**DEPARTMENT OF TRANSPORTATION  
STATE OF GEORGIA**

**FILE:** CSSTP-0007-00(691) Douglas Paulding      **OFFICE:** Engineering Services  
 STP00-0186-01(011) CSSTP-0006-00(900)(901)  
 P.I. Nos.: 0007691/720970/0006900/0006901  
 SR 92 Widening and Reconstruction      **DATE:** August 7, 2009

**SUBJECT: IMPLEMENTATION OF VALUE ENGINEERING STUDY ALTERNATIVES**

# Value Engineering Study Report RESPONSE

**Alternative RW-R-2B**

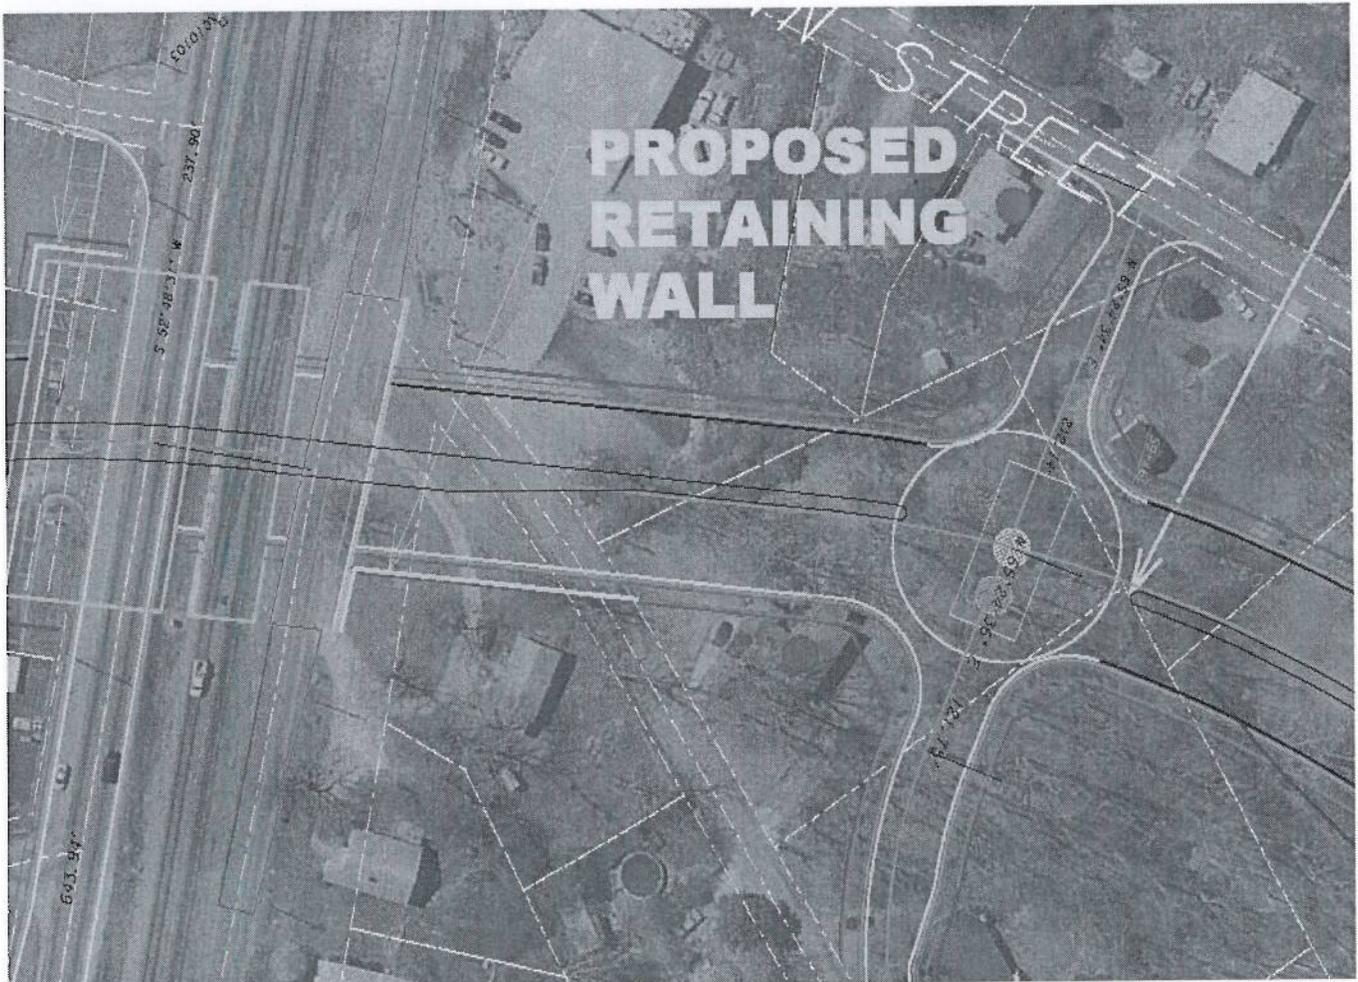
- Description:** Eliminate the SR 92/railroad/US 78 grade separation retaining walls in the northeast quadrant.
- Cost Savings:** \$53,162      *Revised Cost Savings: (-\$189,593)*
- Response:** Agree. Although a revised cost savings has been calculated for this alternative, the length of the proposed wall is only 195 LF. An exhibit displaying the original wall location has been added to the appendix. Based on the original length of wall, a revised cost savings has been created showing the alternative to be a cost increase of \$189,593. Although this is a cost increase, further evaluation of the proposed wall indicates that it may not be a feasible solution. The tie backs for the proposed wall would come too close to the existing home creating a displacement. A revised cost savings worksheet is provided in the Appendix.

**The recommendation of the Office of Urban Design is to implement this request.**

BRIDGE  
TYPICAL SECTION  
EAST BROAD STREET/US 78  
OVER SR 92 REALIGNMENT

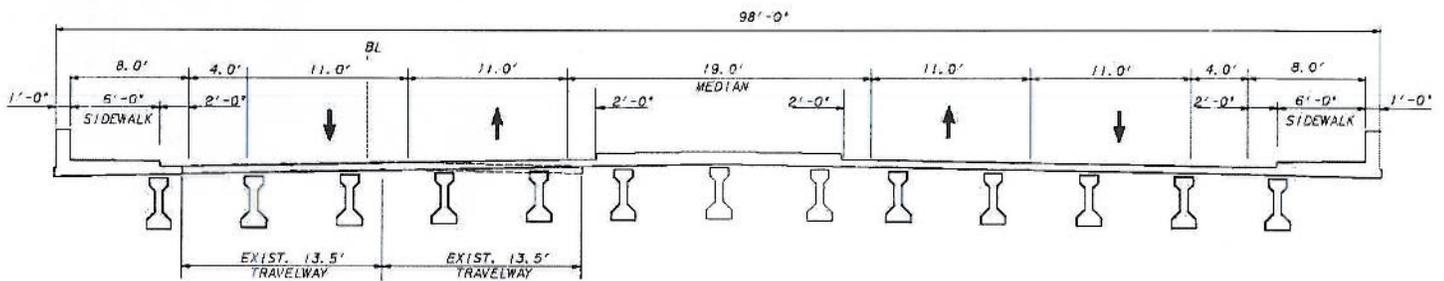
**Description:** Build US 78 bridge for current requirements and widen in the future.  
**Cost Savings:** \$1,116,720 *Revised Cost Savings: \$167,508*  
**Response:** Disagree. This alternative states that the proposed typical section consists of eight lanes totaling 114'-5" in width. This is inaccurate as the proposed typical section consists of six lanes totaling 98' in width. The proposed alternative cost savings would actually be \$818,928. A revised cost savings worksheet is added to the Appendix.

We would like to recommend a new proposed alternative. The revised Concept for GDOT PI No. 721590 – Bankhead Highway from SR 92 to Sweetwater Road is showing a typical section along Bankhead Highway/US 78 consisting of four 11-foot travel lanes, two 4-foot bike lanes, a 19 foot raised median, and a 5-foot sidewalk. We recommend reducing our proposed 6 lane typical section to match the 4 lane section proposed for the upcoming project. A revised typical section has been added to the appendix. Based

on this revised typical section, we have included a revised cost savings worksheet in the Appendix of this document. The new recommendation cost savings is \$167,508.

**The recommendation of the Office of Urban Design is not to implement the alternative from the VE Study report but to implement the proposed alternative listed above..**

# Alternative BRC-3

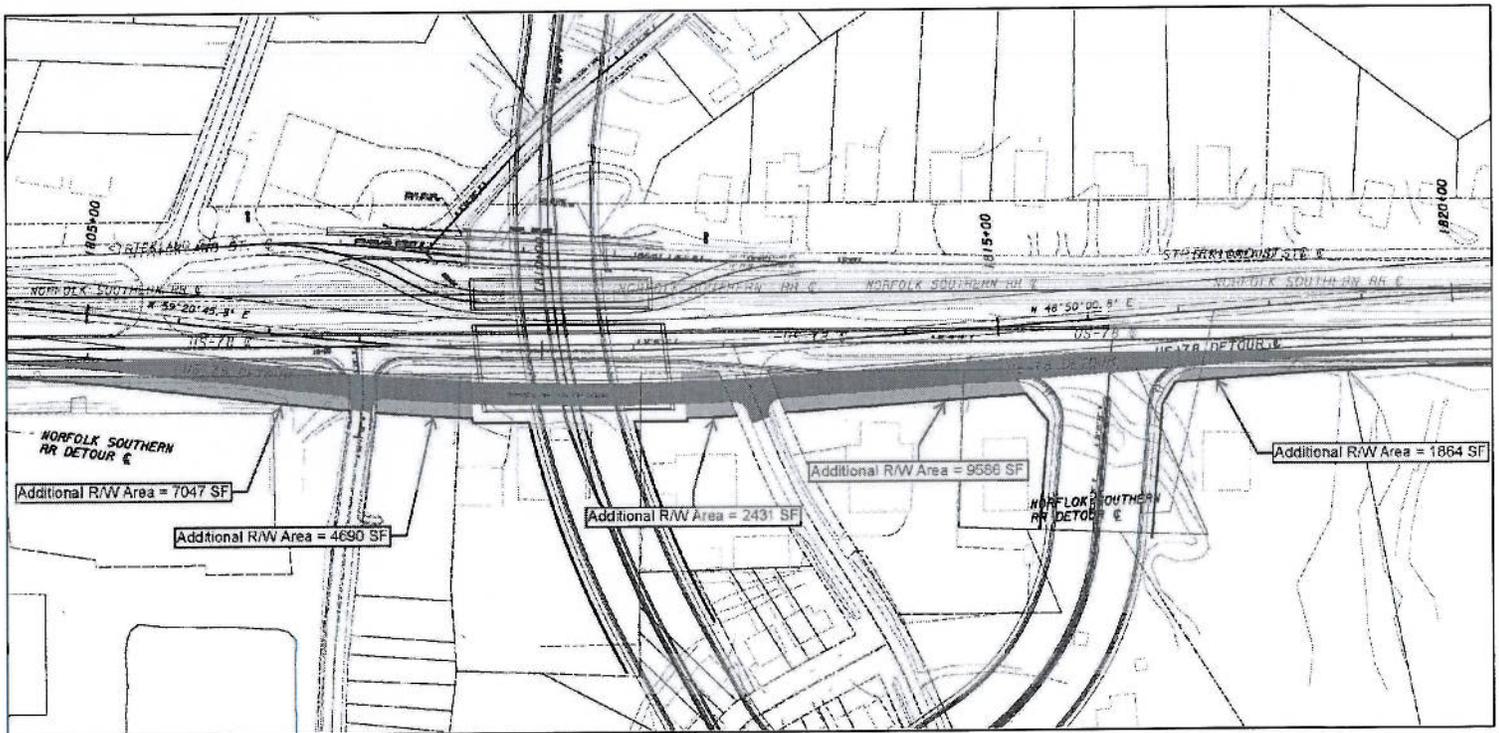
**Response:** Disagree. Building US 78 permanently at the current detour location would also require the purchase of Permanent Right of Way which has been omitted from the cost savings estimate. A new cost savings worksheet is included in the Appendix of this document showing a revised cost savings of \$141,006. This alternative would require additional environmental impacts by requiring a permanent Right of Way take on a parcel in a Historic District eligible for the National Register. Historic sites eligible for the National Register receive special protection under section 4(f) of the Department of Transportation Act (recodified in 49 U.S.C. 303 and 23 U.S.C 138). This evaluation, which typically takes over a year to prepare and review for legal sufficiency, must demonstrate that the impacts to the facility have been minimized and there is no prudent nor feasible alternative to use of the historic property.

**The recommendation of the Office of Urban Design is not to implement this request.**
